Report FL #: 10088 for Greenheck models EHH-601D & ESD-635D (both w/ and w/o VCD-40 Damper)

Report FL #: 10093 for Airolite models SCH601MD & K6746MD (both w/ and w/o VCD-40 Damper)

NOTICE OF ACCEPTANCE (NOA)

APPROVAL DOCUMENT: Drawing No. **EHH-601D**, titled "EHH-601D Louver", sheets 1 through 35 of 35, dated 08/09/2017, prepared by Greenheck Fan Corporation, signed and sealed by Wayne K. Helmila, P.E. on 09/27/2024, bearing the Miami-Dade County Product Control revision stamp with the Notice of Acceptance number and expiration date by the Miami-Dade County Product Control Section.

15B
15
MULLION DETAIL, W/ MULLION ANGLE MOUNTING
LOUVER HEIGHT ≤ 96 IN.
CONTINUOUS ANGLE MOUNT

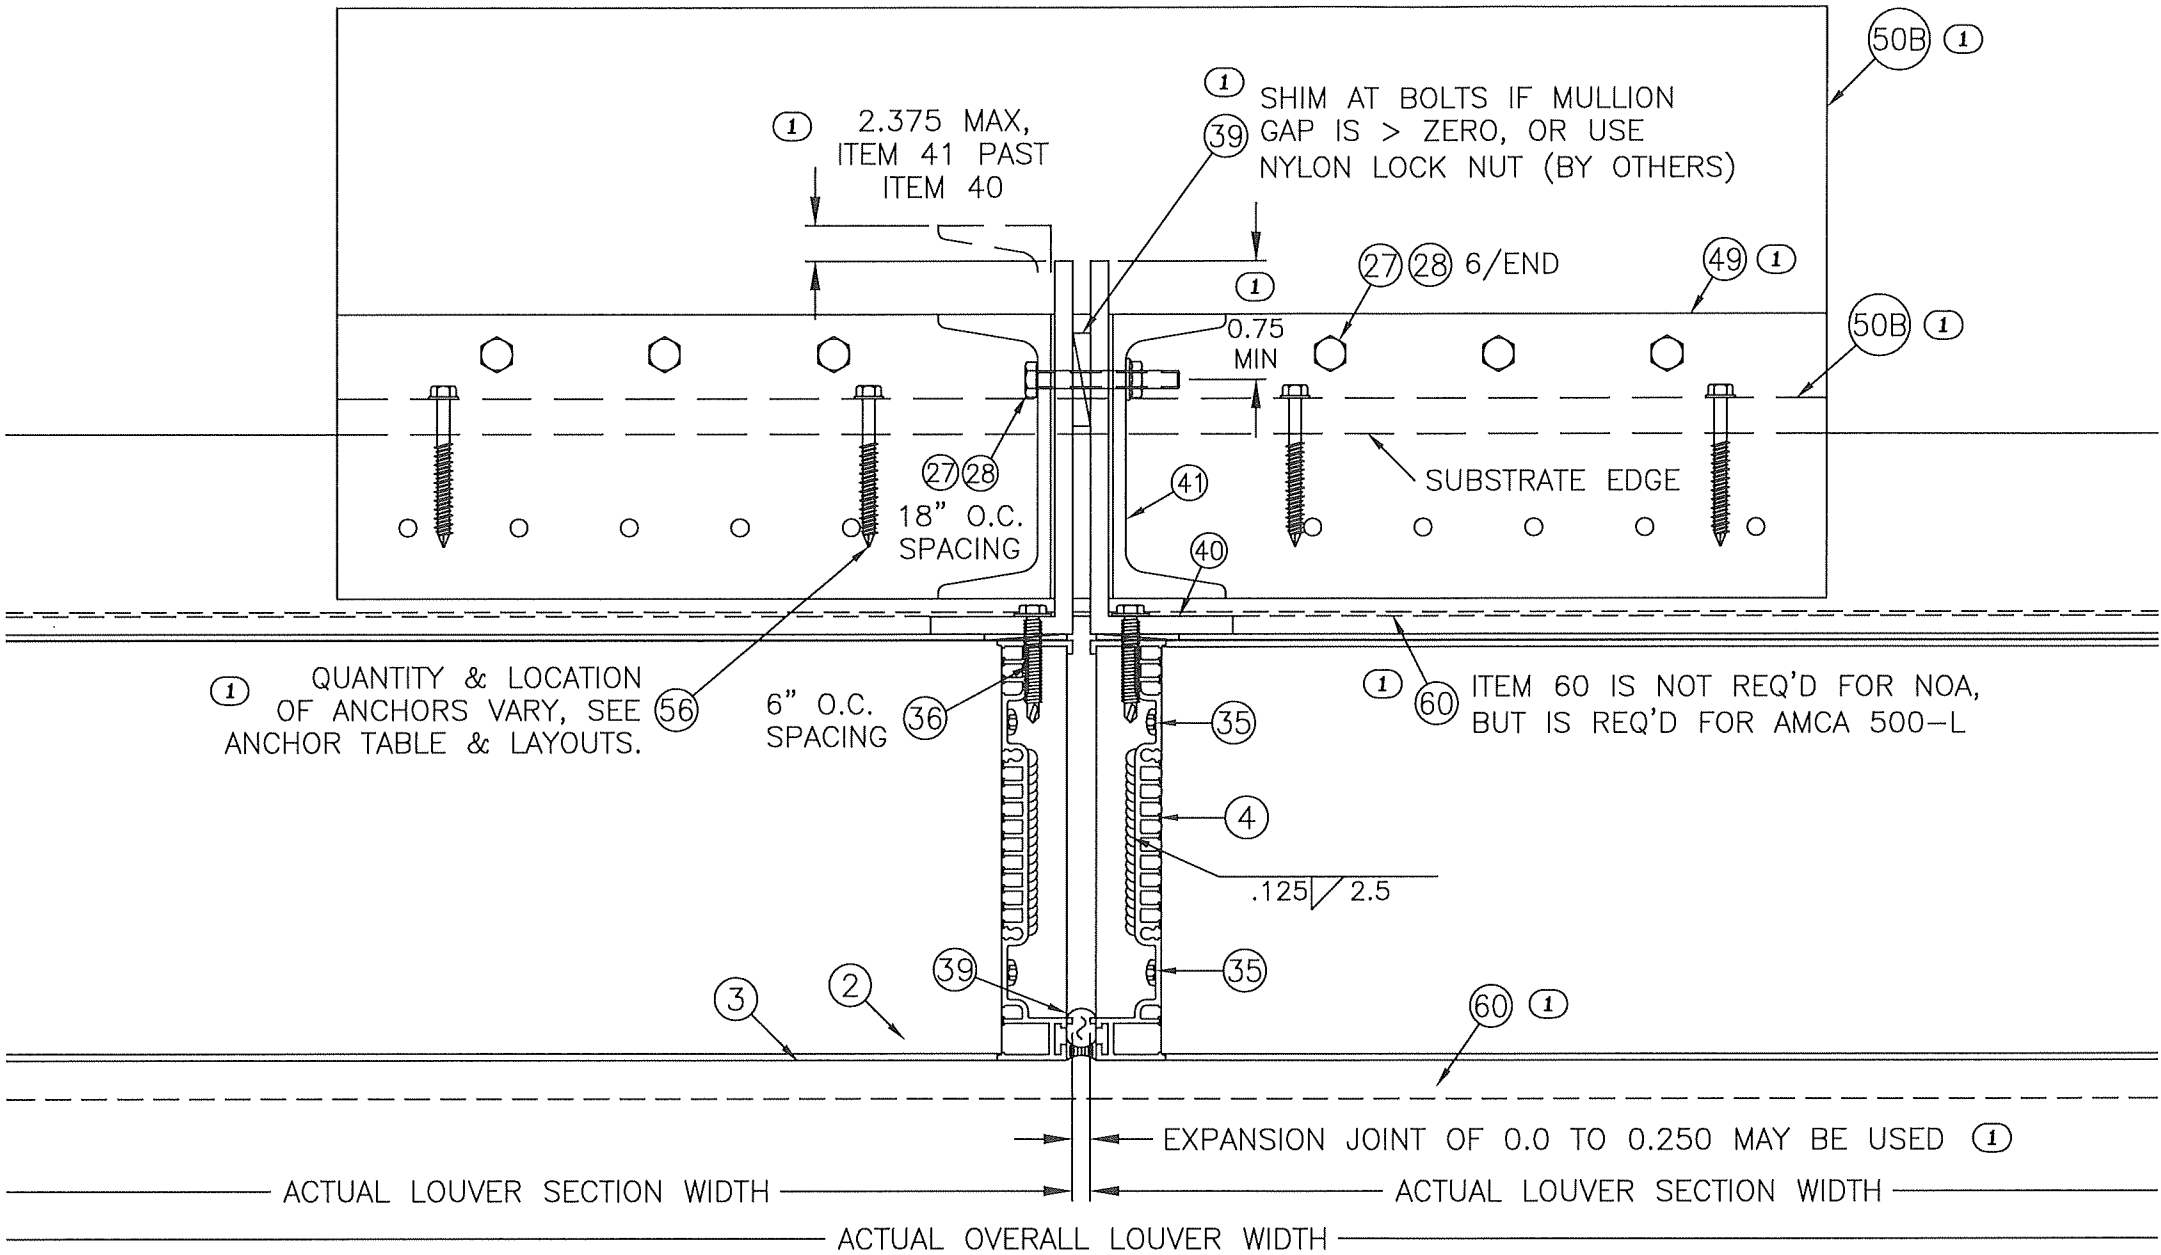
REV 01: 8/1/24, MOVED DETAIL 15B TO THIS NEW PAGE, REPLACED ITEMS
49 & 50B WITH UPDATED DESIGNS, REDEFINED ITEM 41 MAX OFFSET, ADDED
0.75 MIN OFFSET, ADDED ITEM 39 & NOTE, UPDATED ANCHOR REFERENCE
NOTE, REWORDED MULLION GAP NOTE, & ADDED ITEM 60 X2 & ITS NOTE X1.

DRAWN BY MES	DATE 8/9/2017	 GREENHECK P.O. BOX 410 SCHOFIELD, WISCONSIN 54476-0410	SCALE	SHEET NO. 16 OF 35	TITLE EHH-601D LOUVER W/VCD-40 FLANGE FRAME SLEEVE MOUNT & CONTINUOUS ANGLE MOUNT HEAD & SILL DETAILS, HS144"
CAD DRAWING NO. EHH-601D

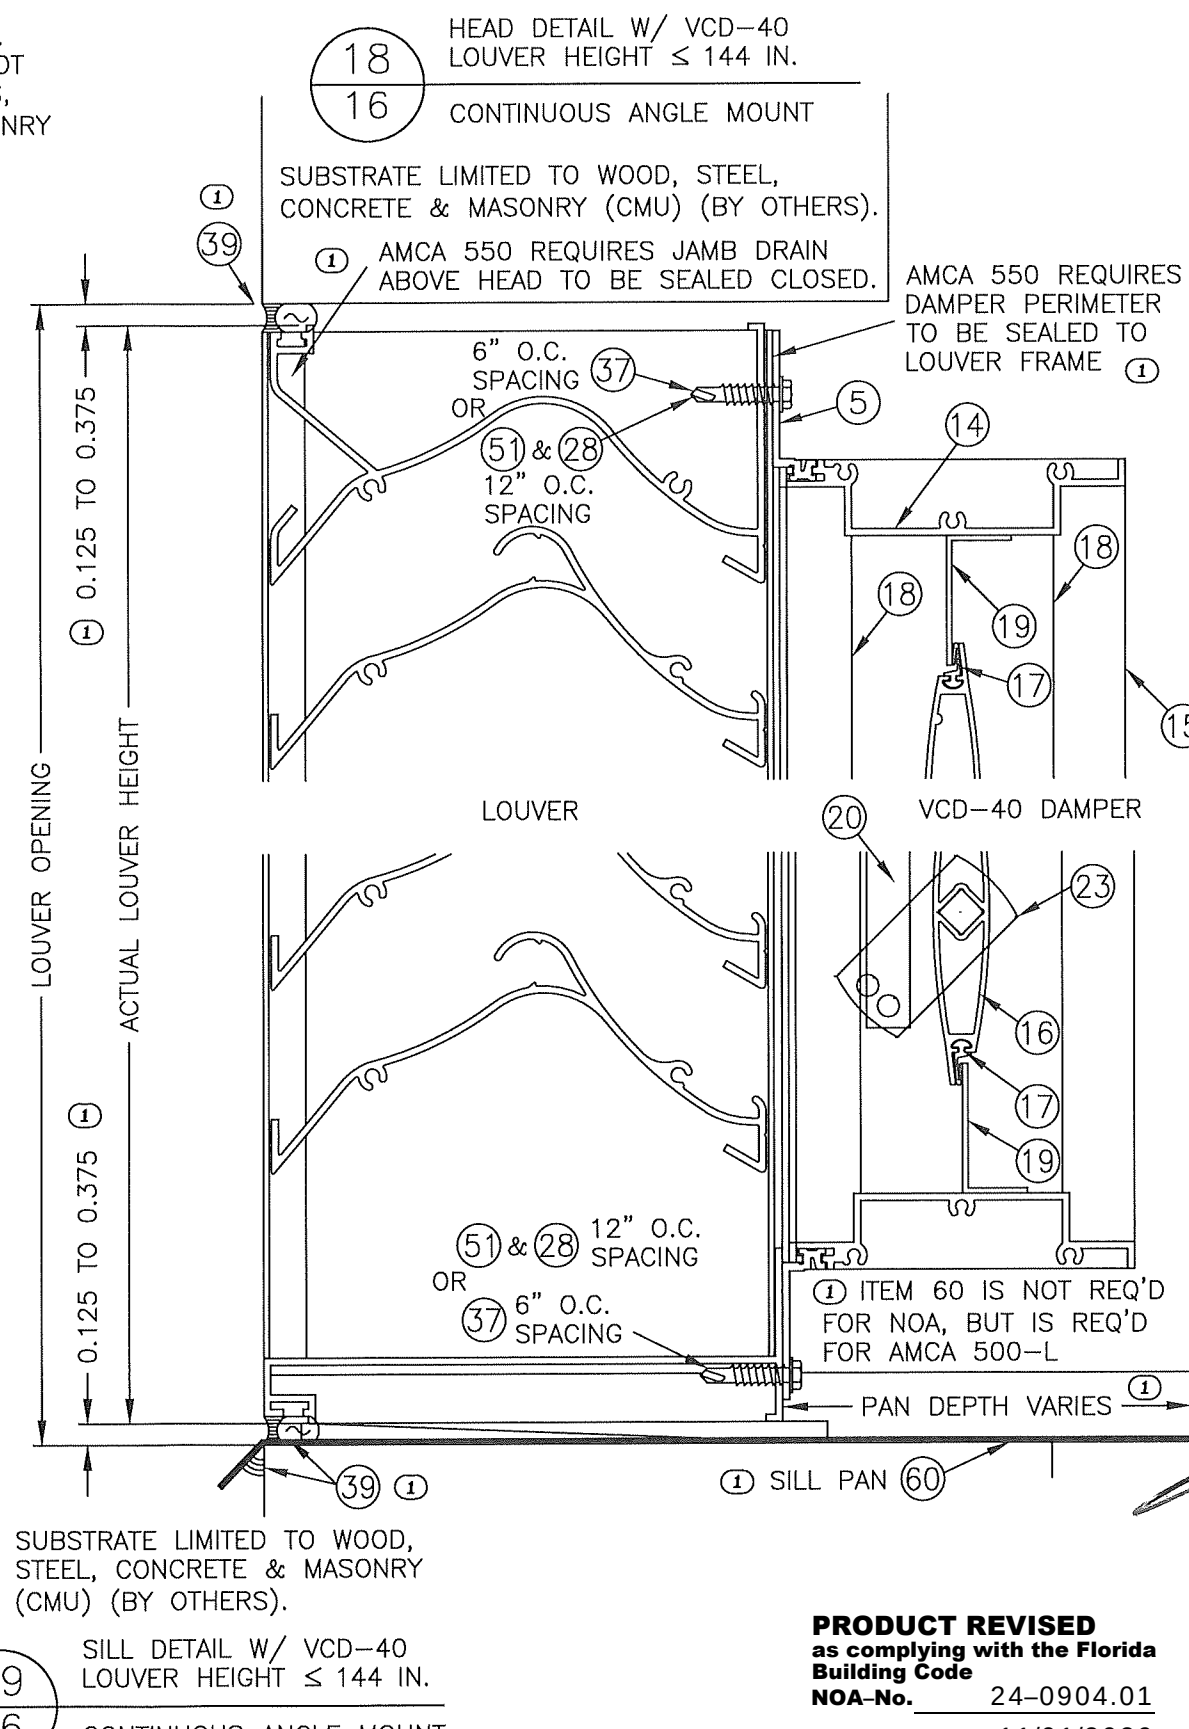
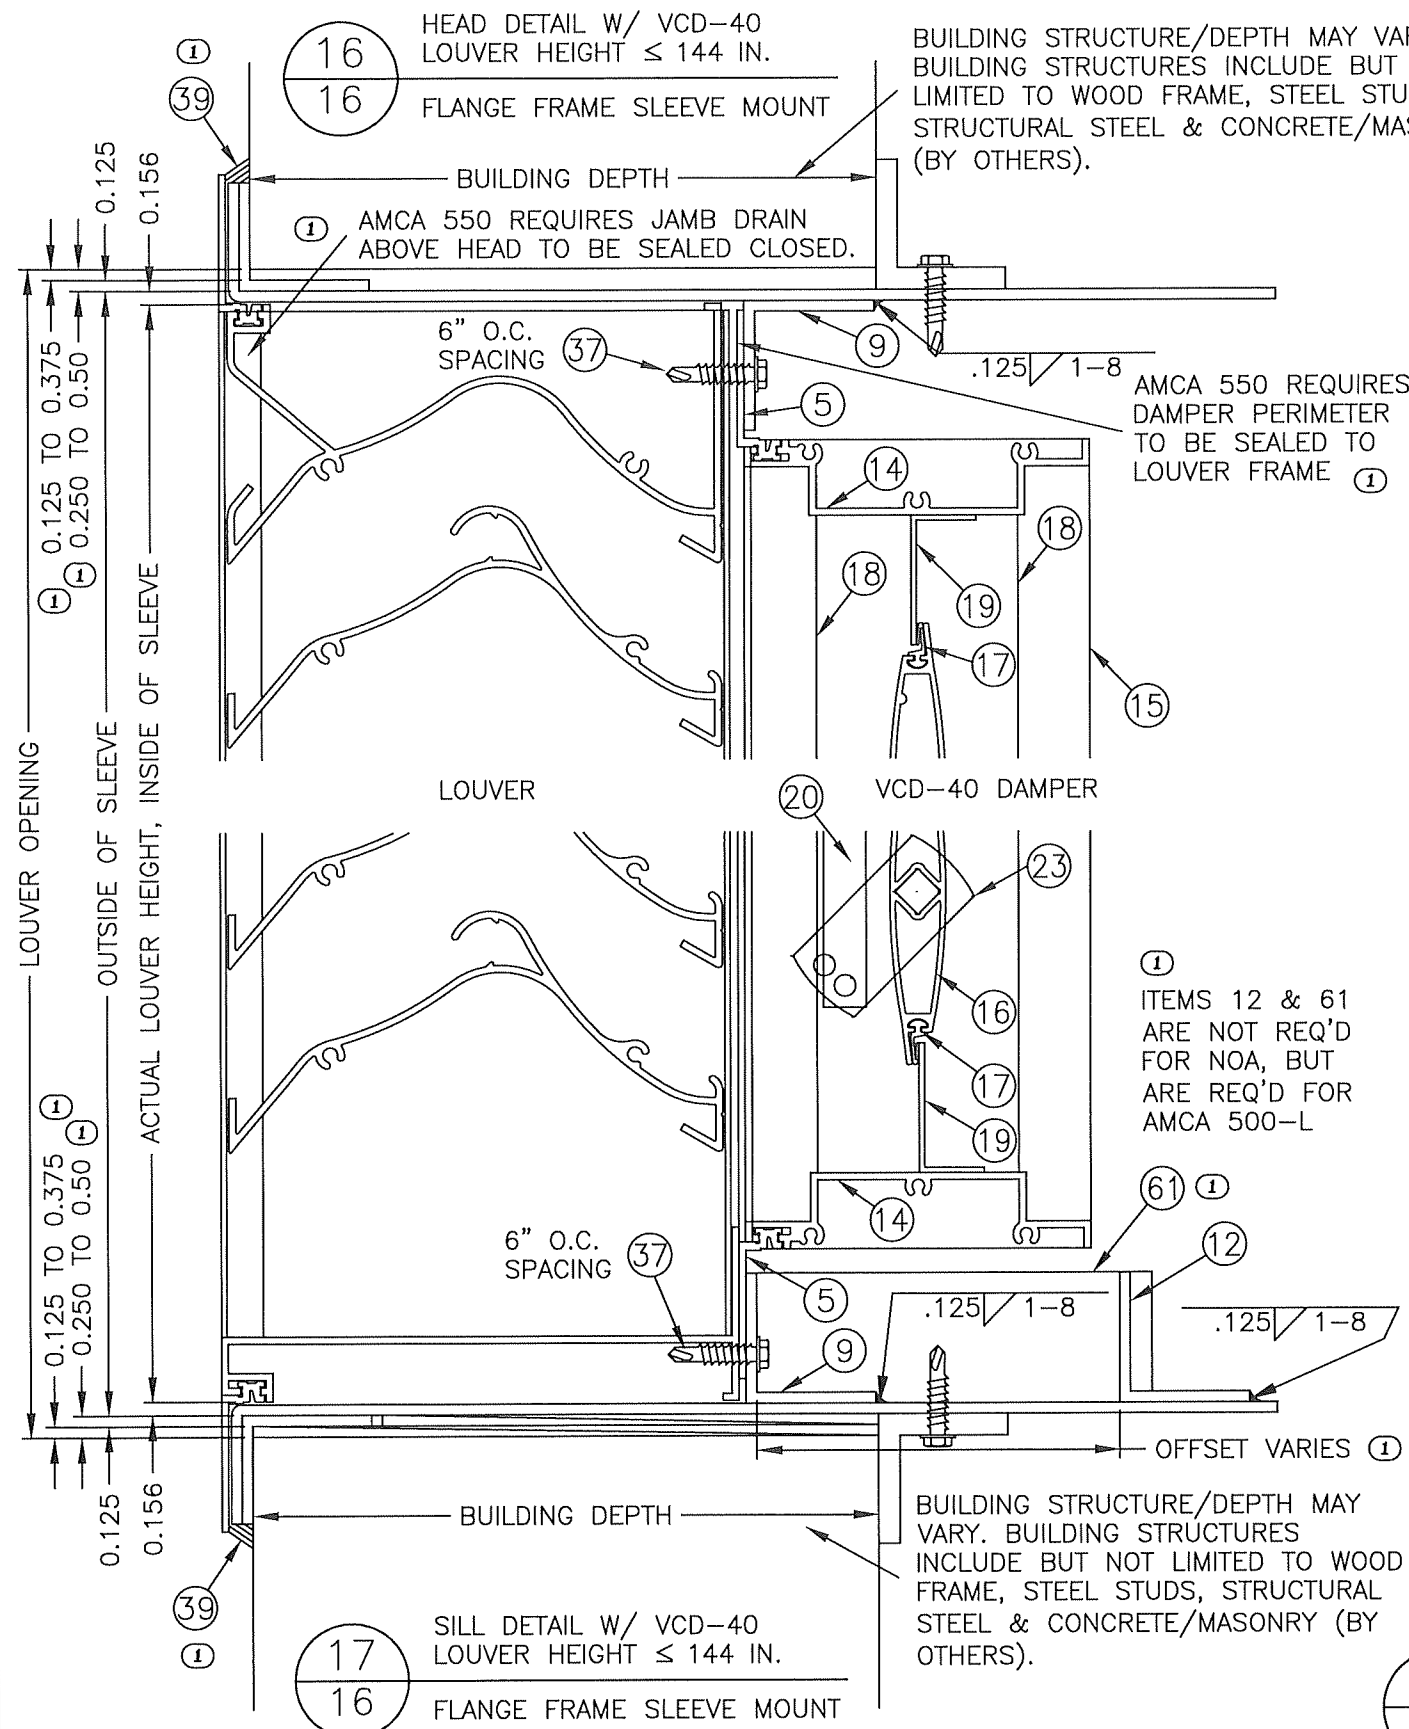
REV 01: 8/1/24, WAS PAGE 13, REMOVED "TYP" FROM EDGE GAP X6, ADDED ITEM 39 X4, ADDED AMCA 550 NOTE X4, ADDED ITEM 12/61 NOTE, ADDED ITEM 61 & ITS OFFSET, REMOVED ITEM 44 & ITS FASTENERS, ADDED ITEM 60 NOTE, & ADDED ITEM 60 & ITS OFFSET.

GREENHECK P.O. BOX 410 SCHOFIELD, WISCONSIN 54476-0410		DRAWN BY	DATE
			MES	8/9/2017
			SCALE	
			SHEET NO.	
TITLE		18 OF 35		
EHH-601D LOUVER W/VCD-40		CAD DRAWING NO. EHH-601D		
FLANGE FRAME SLEEVE MOUNT				
JAMB DETAILS				
H≤144"

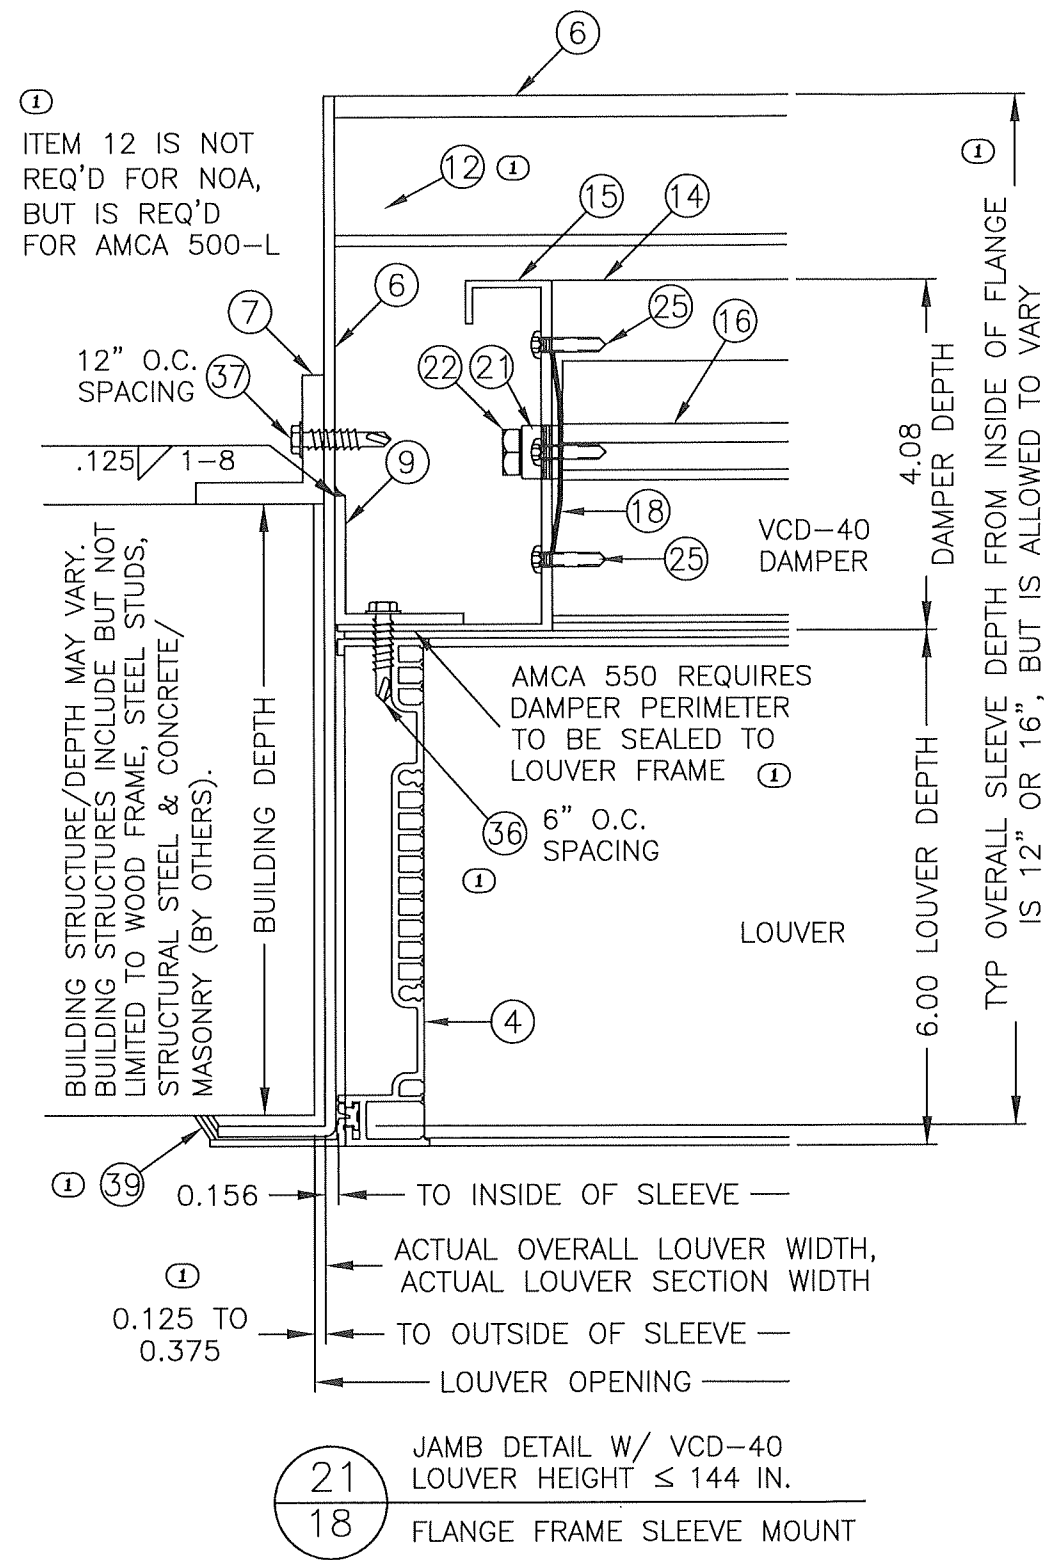
REV 01: 8/1/24, WAS PAGE 15, MOVED DETAILS 22A&B TO A NEW PAGE, REPLACED ITEM 37 WITH ITEM 36, ADDED SLEEVE DEPTH DIM, ADDED ITEM 39, REMOVED "TYP" FROM EDGE GAP, ADDED ITEM 12 WITH NOTE, & ADDED AMCA 550 NOTE.
